BRENDA PARKER SUBDIVISION

APPLICATION NUMBER 9 DATE April 21, 2011

REQUEST Subdivision

DETAIL SITE PLAN

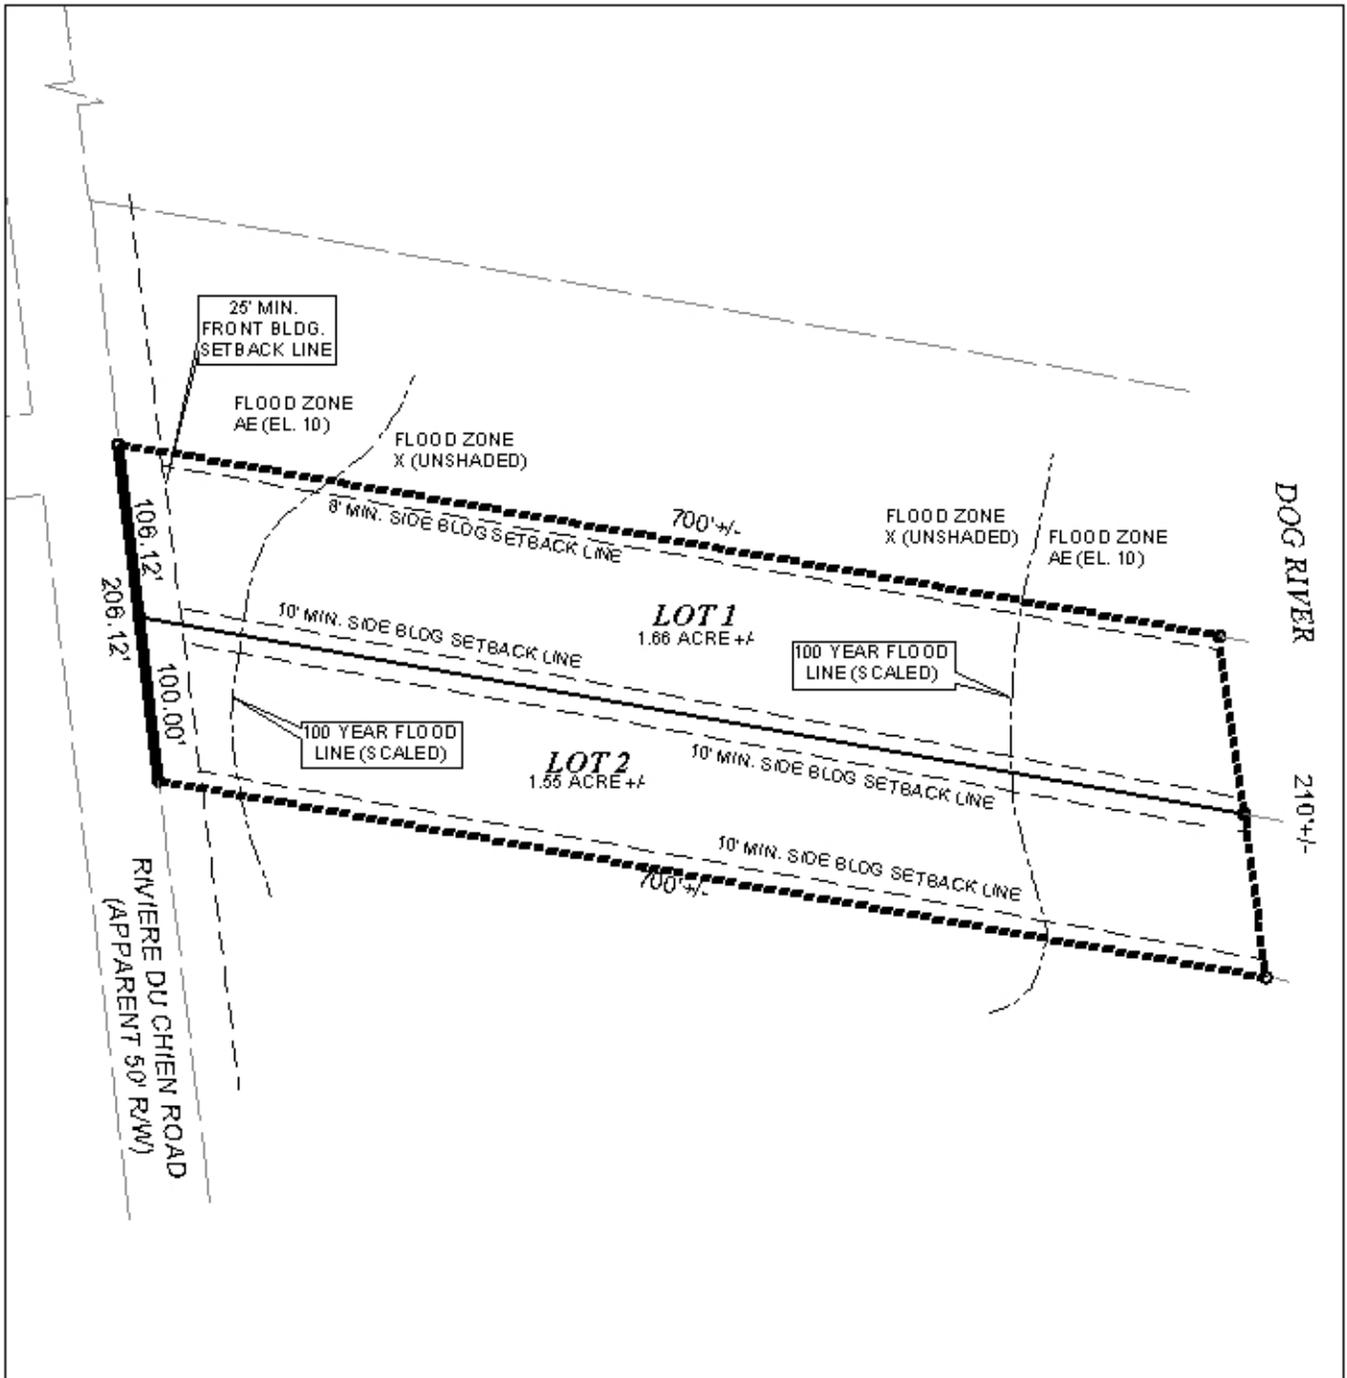
Engineering Comments: Check the flood zones shown on the plat; it appears the entire site is AE/X-Shaded flood zone. Show the minimum finished floor on each lot on the plat. It is the responsibility of the applicant to look up the site in the City of Mobile (COM) GIS system and verify if NWI wetlands are depicted on the site. If the COM GIS shows wetlands on the site, it is the responsibility of the applicant to confirm or deny the existence of wetlands on-site. If wetlands are present, they should be depicted on plans and/or plat, and no work/disturbance can be performed without a permit from the Corps of Engineers. Must comply with all storm water and flood control ordinances. Any work performed in the right of way will require a right of way permit.

The site fronts onto Riviere du Chien Road , a minor street with adequate right-of-way. While it is a minor right-of-way, access management is a concern. Each lot should be limited to one curb cut onto Riviere du Chien Road, with the size, design and location to be approved by Traffic Engineering and conform to AASHTO standards, if the subdivision is approved.

As proposed, both lots would exceed the maximum width to depth ratio as recommended by the Subdivision Regulations; therefore, a waiver of Section V.D.3., would be required. Since narrow, deep lots are typical of the area, a waiver of V.D.3. would be appropriate.

Each lot meets the minimum requirements of the Subdivision Regulations. As on the preliminary plat, the Final Plat should also label each lot with its size in both square feet and acres, or a table should be furnished on the Final Plat providing the same information. And the 25' minimum building setback line should also be illustrated on the Final Plat as on the preliminary.

The plat indicates a proposed 10' minimum side yard setback on the South side of proposed Lot 1, and an 8' minimum side yard setback on its North side, for a combination of 18' side yards. The Zoning Ordinance requires a minimum side yard combination of 20' for lots wider than 60' at the building setback line, as this lot would be, if approved. A letter furnished with the application requests a variance for the combined side yard setbacks. However, a Planned Unit Development application for an innovative subdivision with reduced side yards or a Combined Side Yard Setback Variance application would be required to allow the reduced side yards. As a one-lot innovative subdivision is not indicated in this situation, the applicant should pursue a Variance through the Board of Zoning Adjustment to allow the proposed reduced combined side yards as the proposed reduced side yard combination is located on an external lot. The plat should be revised to remove the minimum side yard setbacks on both lots.

The current land use survey indicates structures on the site which are not indicated on the preliminary plat. Required setbacks for the structures off the proposed internal property line cannot be determined. Therefore, the plat should either be revised to indicate the structures meet the required minimum 8' side yard setback off the new interior property line or noncompliant structures should be demolished prior to signing the Final Plat.

It should be noted that the site is located within the X-unshaded and AE flood zones as shown on FEMA Flood Insurance Rate Maps. The site is on Dog River, and wetlands and floodplains associated with the waterway may occur on a portion of the site. The presence of wetlands and floodplains would indicate that the area may be environmentally sensitive; therefore, if approved, the approval of all applicable federal, state and local environmental agencies would be required prior to the issuance of any permits or land disturbance activities.

- 1) placement of a note on the Final Plat stating that each lot is limited to one curb cut to Riviere du Chien Road, with the size, design and location to be approved by Traffic Engineering and conform to AASHTO standards;
- 2) labeling of each lot with its size in acres and square feet, or the furnishing of a table on the final plat providing the same information;
- 3) illustration of the 25' minimum building setback line on each lot;
- 4) revision of the plat to remove the proposed minimum side yard setbacks on both lots;

- 5) revision of the plat to illustrate existing structures meet the minimum side yard setbacks off the proposed interior property line or demolition of noncompliant structures prior to signing the Final Plat;

- 6) placement of a note on the Final Plat stating that if NWI wetlands are present on the site, the approval of all applicable federal, state and local agencies would be required prior to the issuance of any permits or land disturbance activities;

- 8) subject to the Engineering Comments: *(Check the flood zones shown on the plat; it appears the entire site is AE/X-Shaded flood zone. Show the minimum finished floor on each lot on the plat. It is the responsibility of the applicant to look up the site in the City of Mobile (COM) GIS system and verify if NWI wetlands are depicted on the site. If the COM GIS shows wetlands on the site, it is the responsibility of the applicant to confirm or deny the existence of wetlands on-site. If wetlands are present, they should be depicted on plans and/or plat, and no work/disturbance can be performed without a permit from the Corps of Engineers. Must comply with all storm water and flood control ordinances. Any work performed in the right of way will require a right of way permit).*
